Project Name: Gier Park - HVAC

Project No.: 221125-050

This Addendum is issued to inform the bidders of modifications in the scope of work being bid for this project.

**END OF ADDENDUM NO. [#2]**

## 5 GROUPED PIPE CURB DETAIL

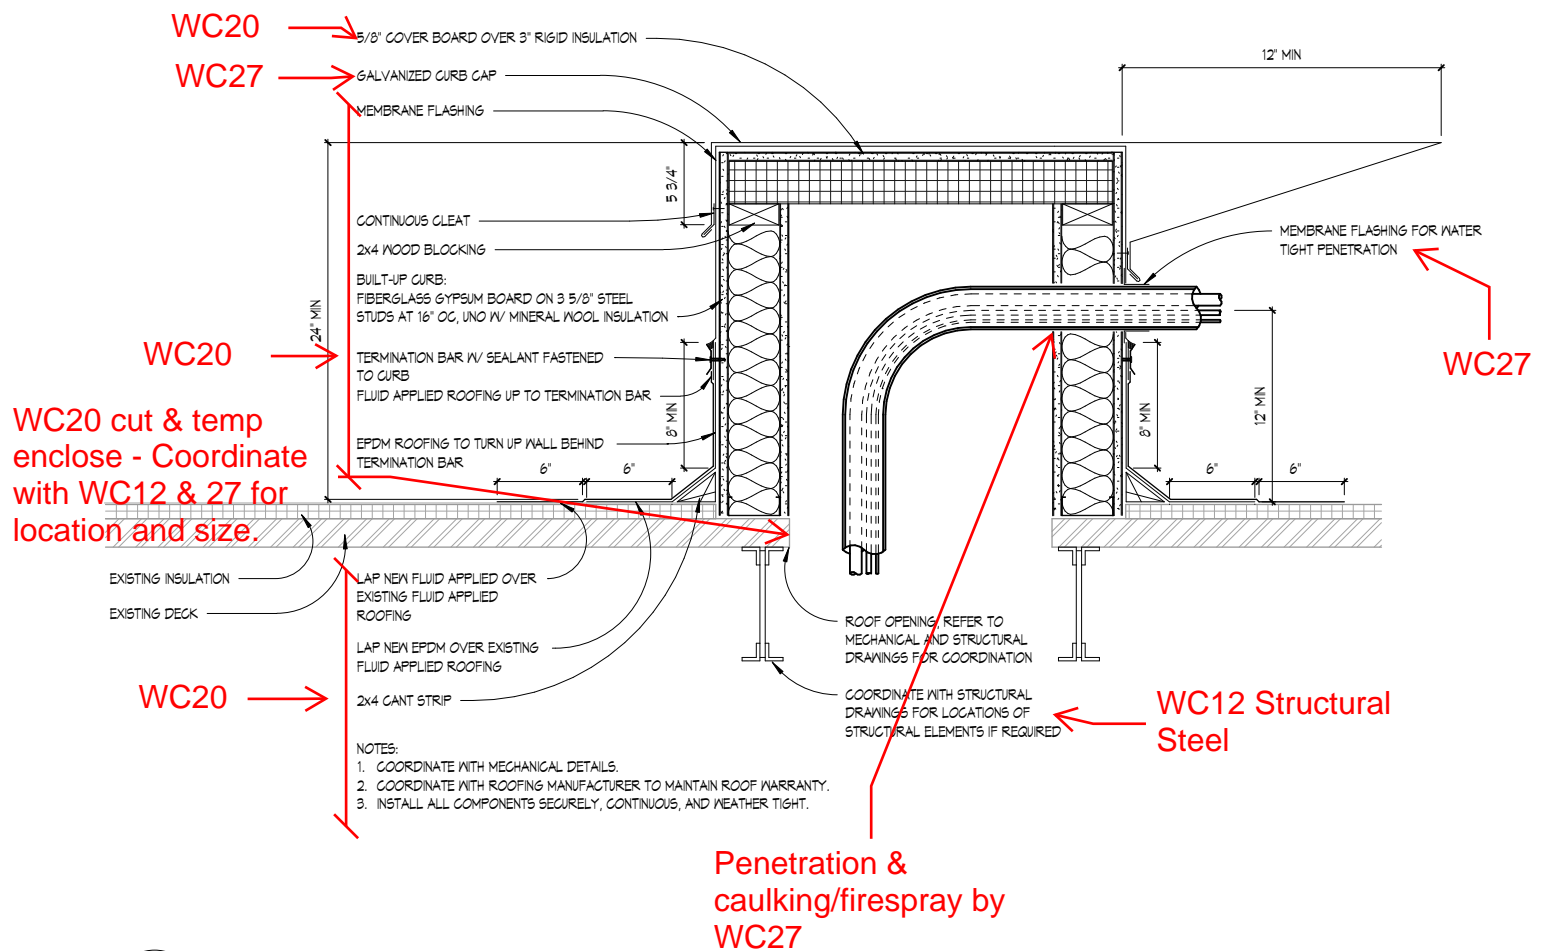
On drawing A5.1 Detail 5 it is showing a roof curb. Can we use Portals-plus in lieu of the curbs, which are attached on top of roof membrane then striped-in per manufactures specifications and warranty specification. These have been used and approved in the past on the Lansing schools.

Please confirm if these pipe portals could be used in conjunction with a sheet metal enclosure, the basis of design is to have a covered pipe curb to protect pipe penetrations in the roof. See the attached picture for an example of what we are intending to achieve with these covered pipe curbs.

ROOF MECHANICAL DEMOLITION PLAN - UNIT 200  
SCALE: 3/32" = 1'-0"

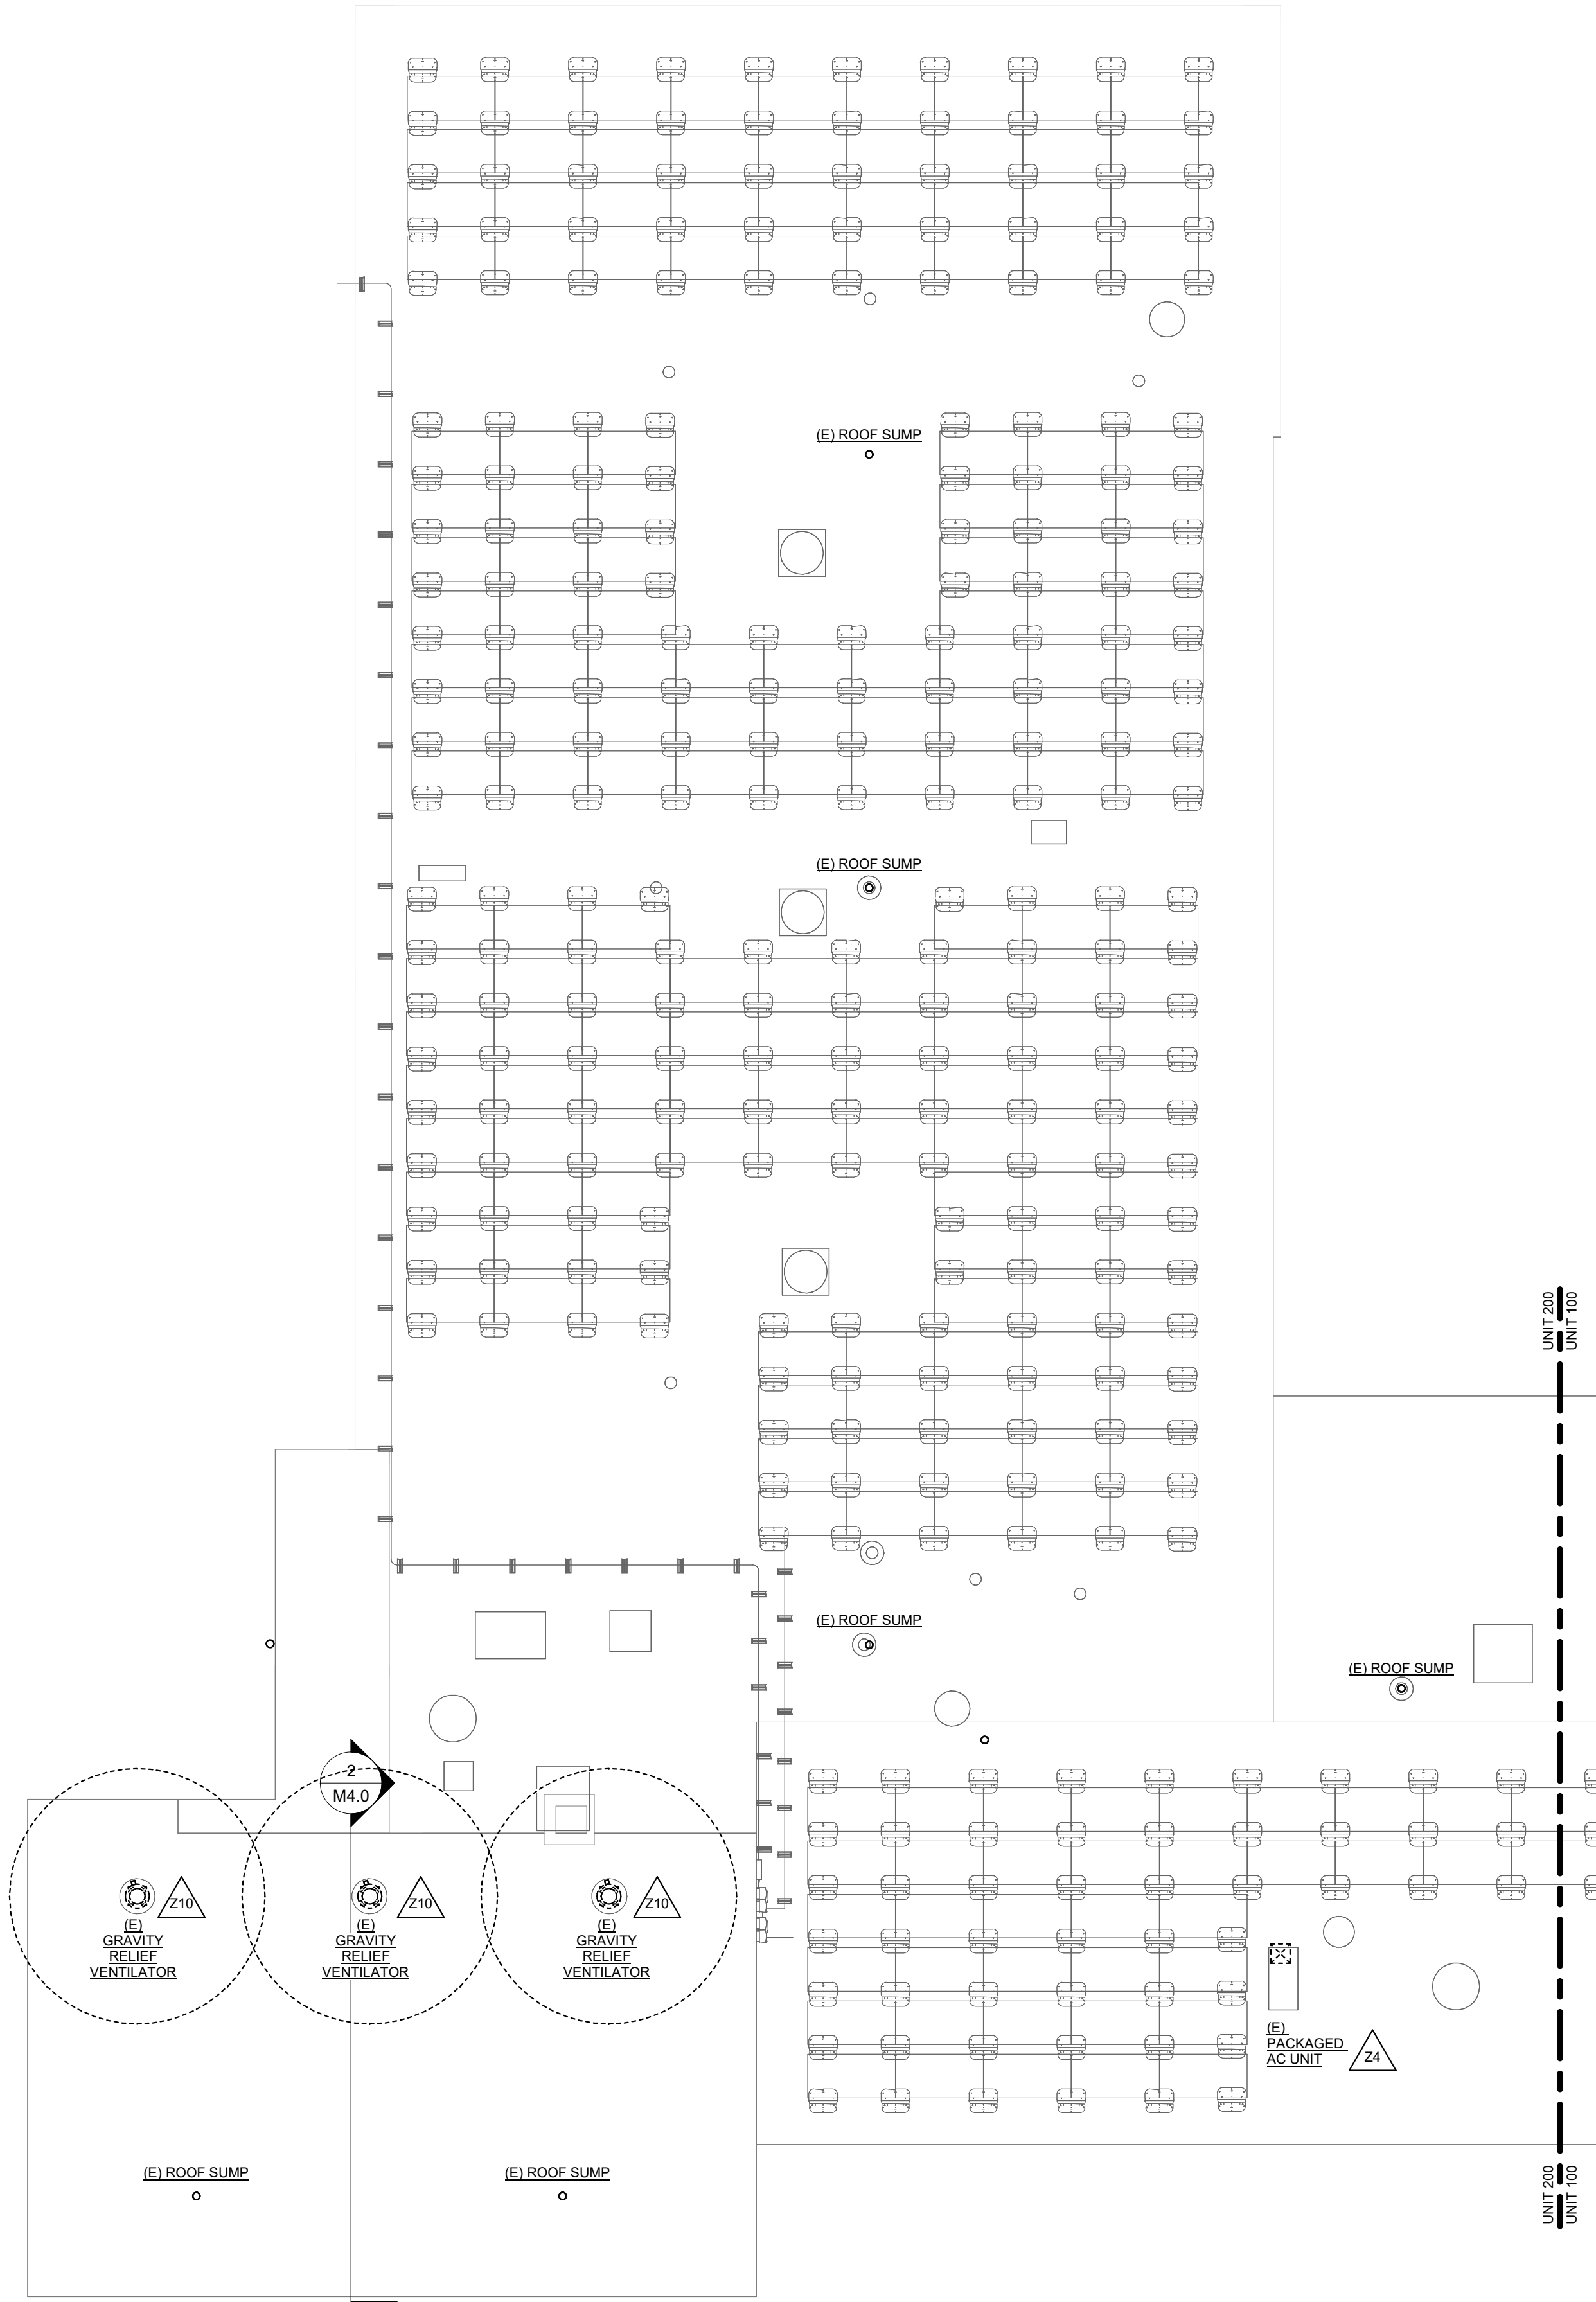
- Revised demolition keynote language.

HEATING HOT WATER SYSTEM PIPING DIAGRAM  
NO SCALE

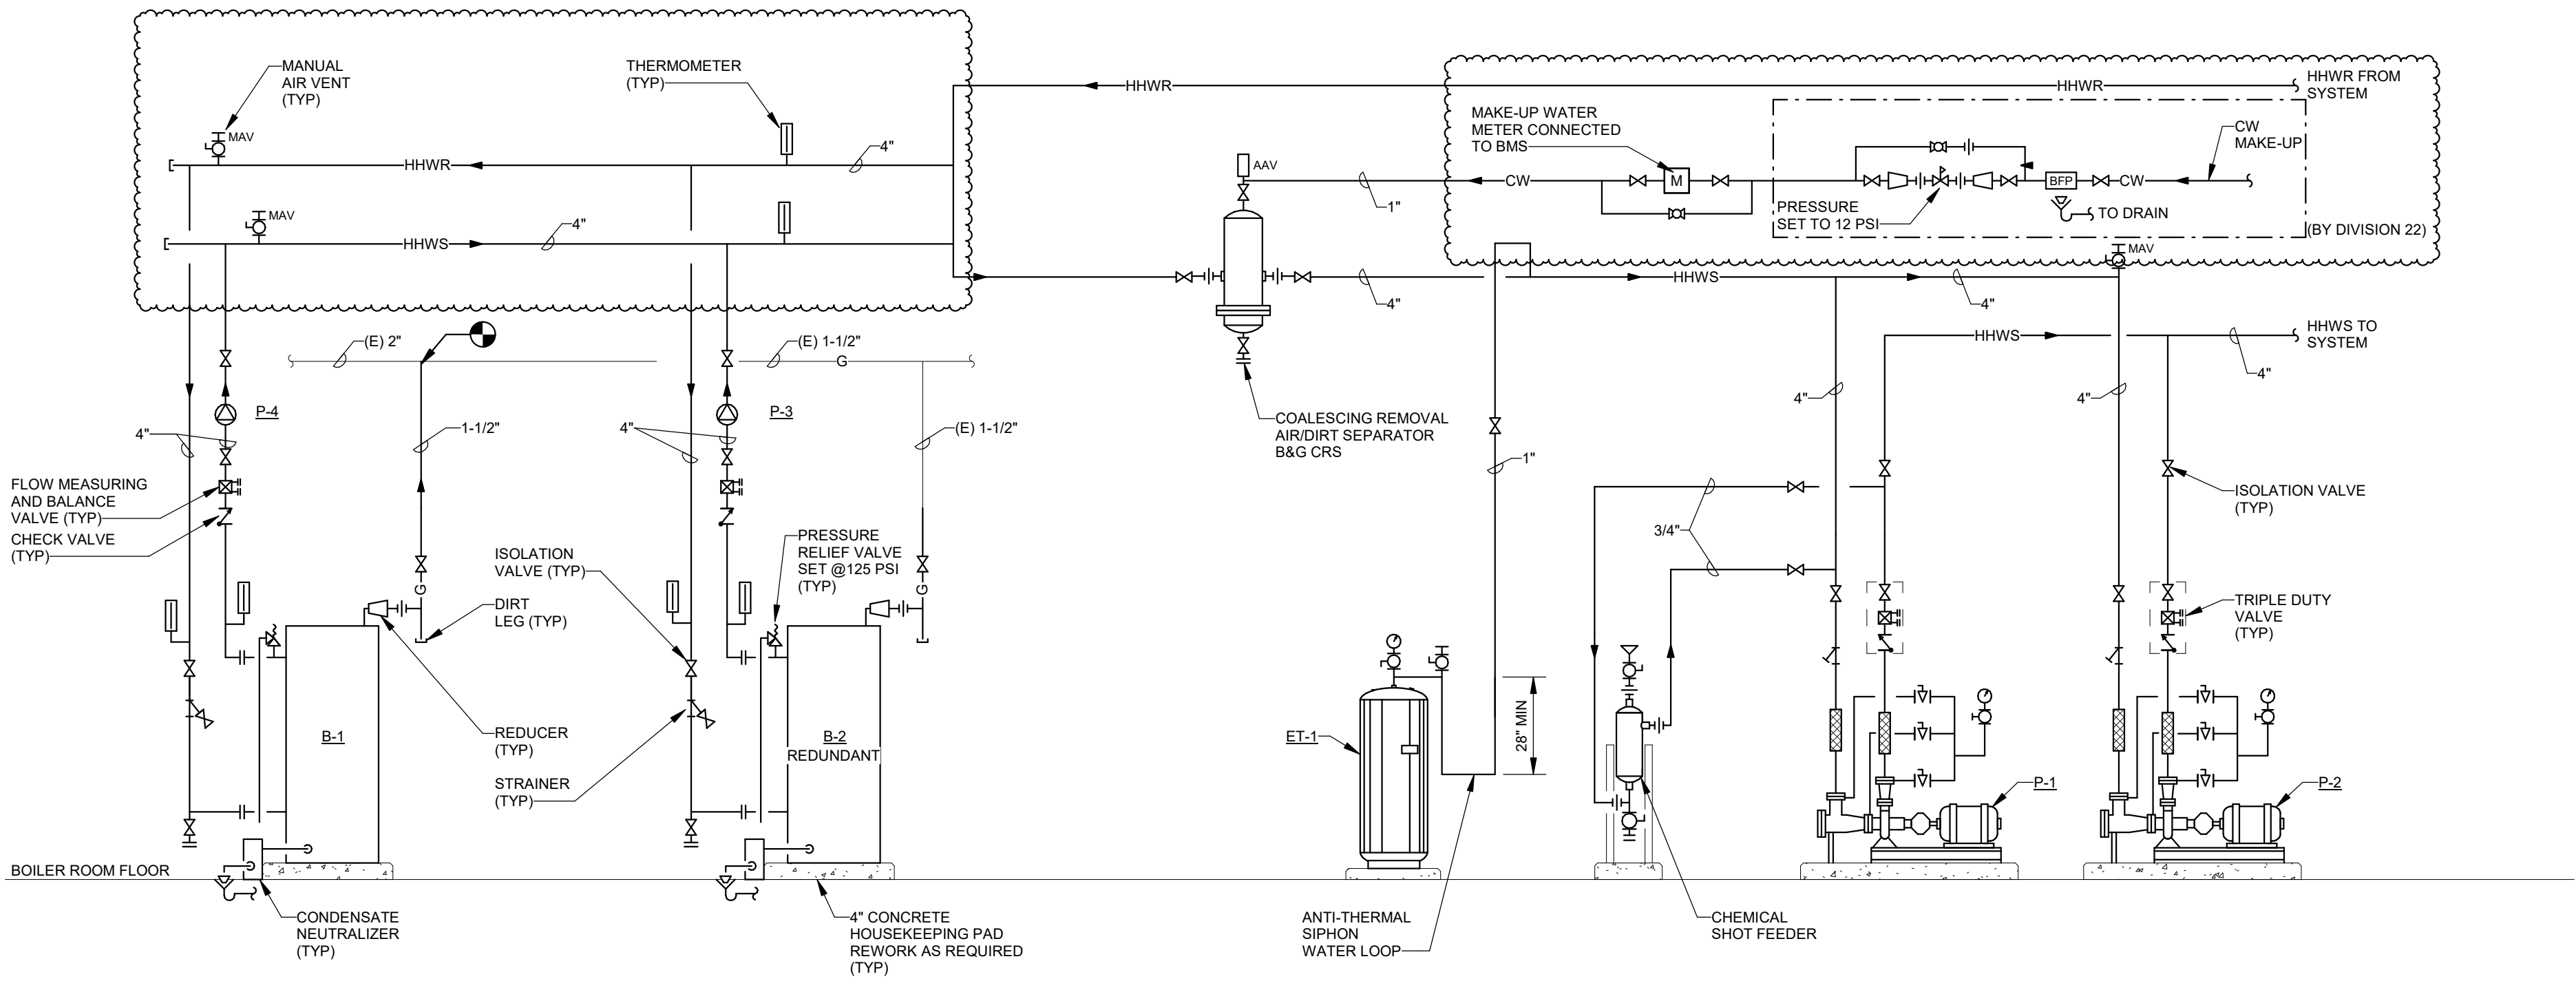
- Revised piping diagram to show a primary/secondary system in lieu of a variable primary systems.
- Edited gas riser diagram to show existing vs new scope.
